**RE: Grading and Drainage Plan for Mello Subdivision, Tract C, Lands of Kirby
(D32/D1) (PWD-97-162) Submitted for Preliminary Plat Approval, Engineer's
Stamp Dated 12/17/97.**

Bernalillo County Public Works Division Case File Comments

Case Number PWD 97 162

GRADING & DRAINAGE PLAN

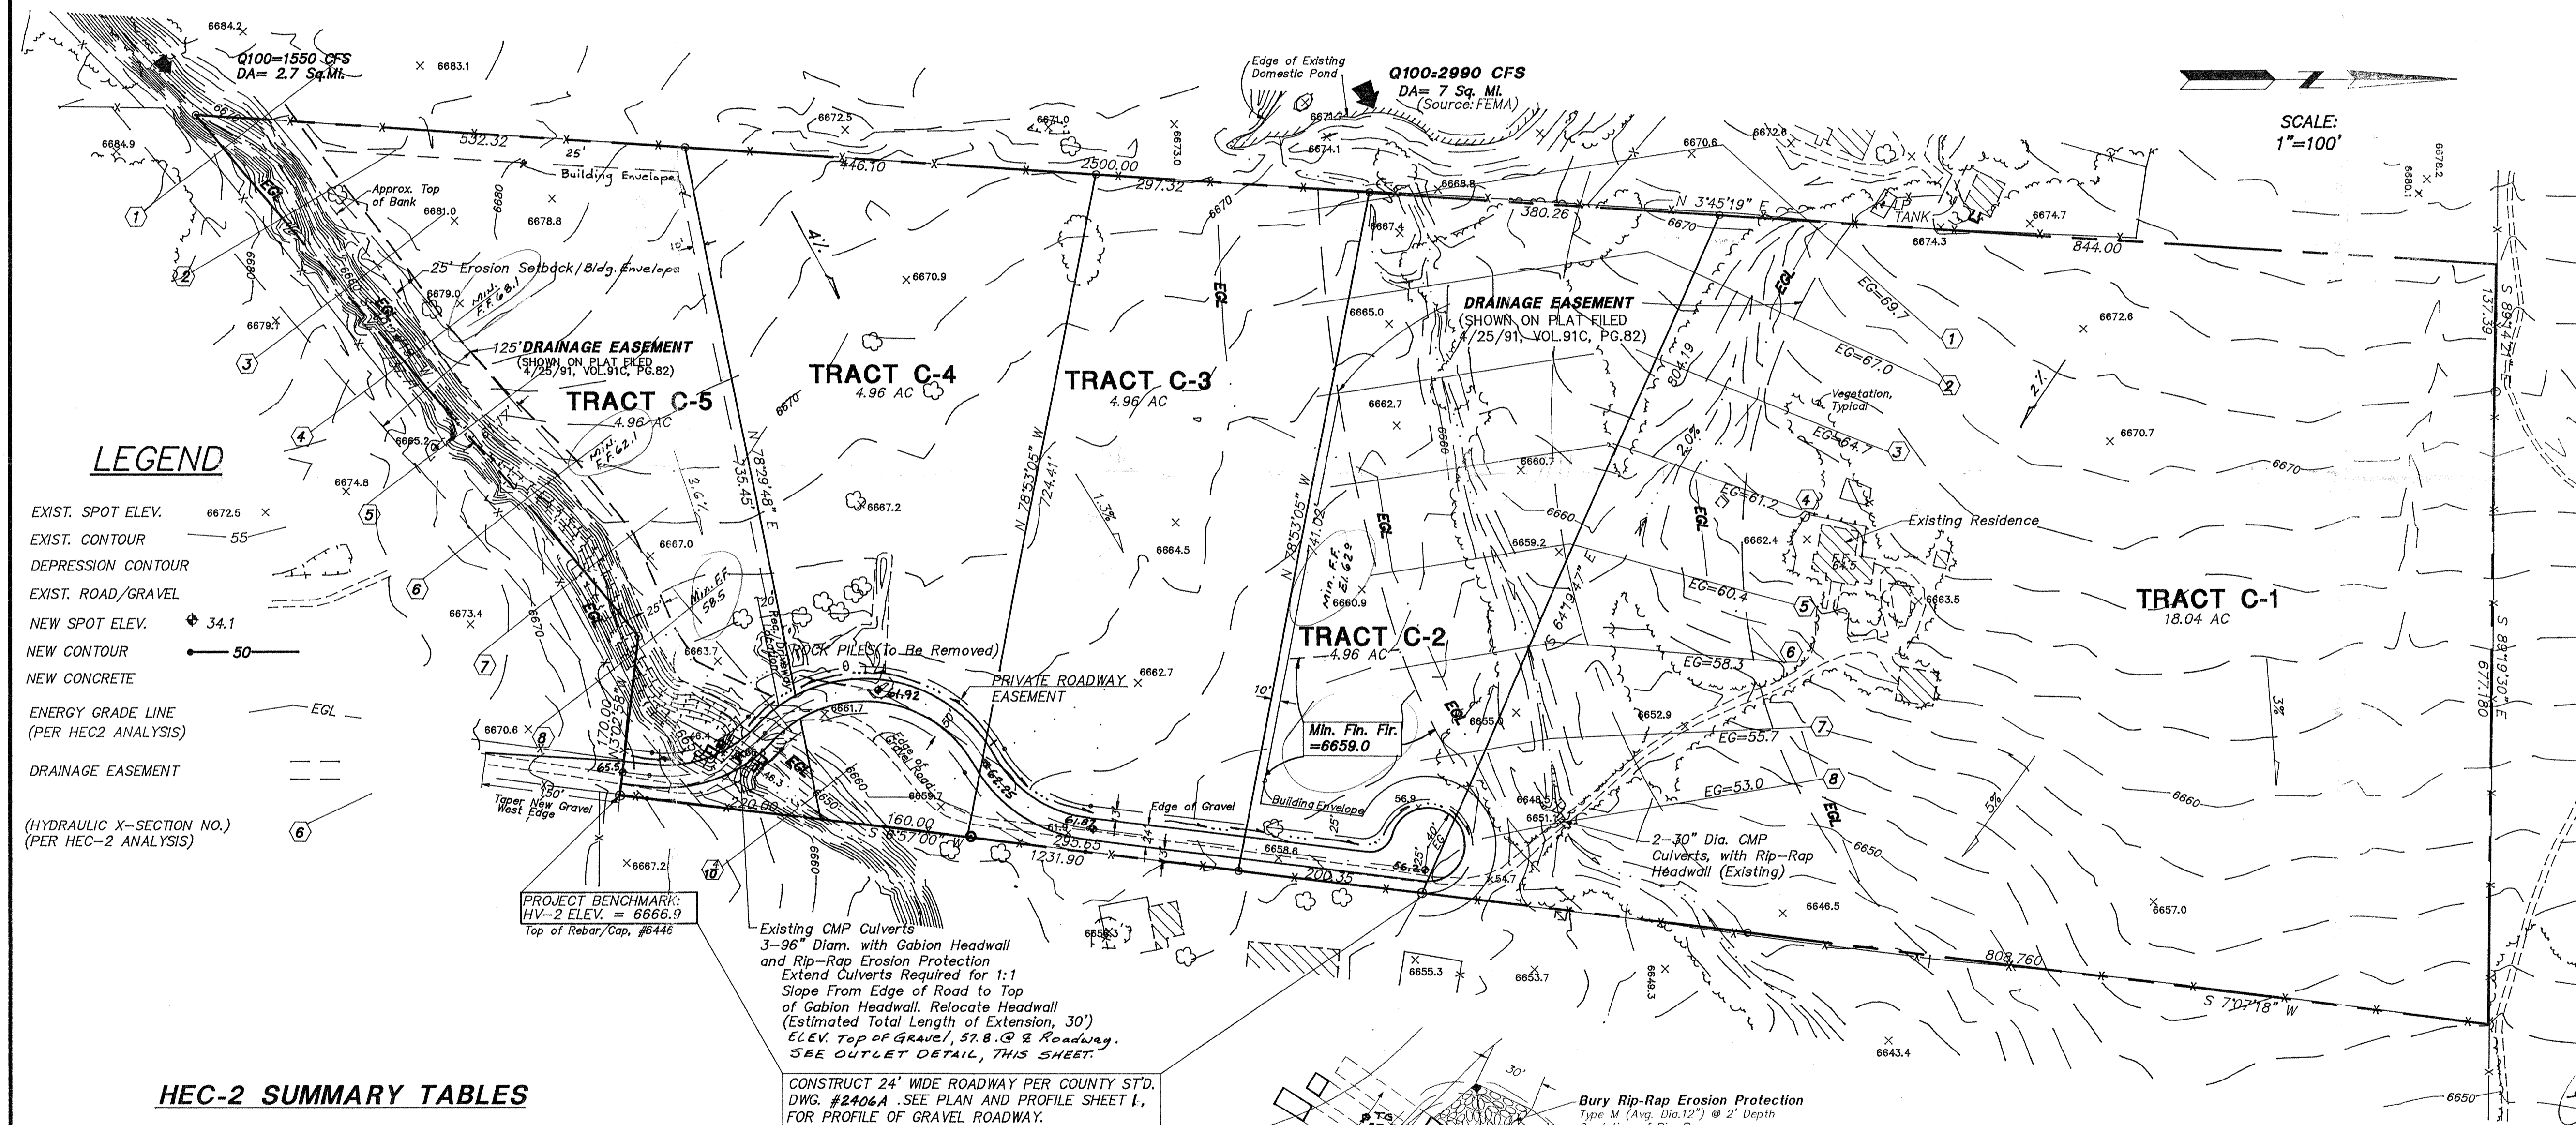
1. Please clarify the minimum finished floor elevations with respect to locations for Tracts C-2 and C-

5. *Identify bldg envelope*

2. The two-30 inch culverts in the San Pedro Creek are not adequate to pass the 10-year or 100-year storm. The water will overtop these culverts and impact the cul d sac. ~~Erosion protection may be necessary at the inlets and outlets.~~ *please address*

3. Is erosion protection necessary at the outfall of the three 96-inch culverts in the Armijo Arroyo. Are these culverts designed for the 10 or 100 year event. ? *hard ditch to end of cul de sac - how does it get thru rip rap?*

4. Was an AHYMO analysis completed for the Armijo Arroyo. ?

6. The erosion setback analysis for the Armijo and San Pedro is a little bare. A brief discussion on the type of material and its erosion abilities to with-stand velocities in excess of 10 to 18 fps, historic flow patterns, movement of arroyos in last 10, 20, 30 years, etc. should be addressed.

* *(exist cul de sac bulb @ Subd. entrance?)*
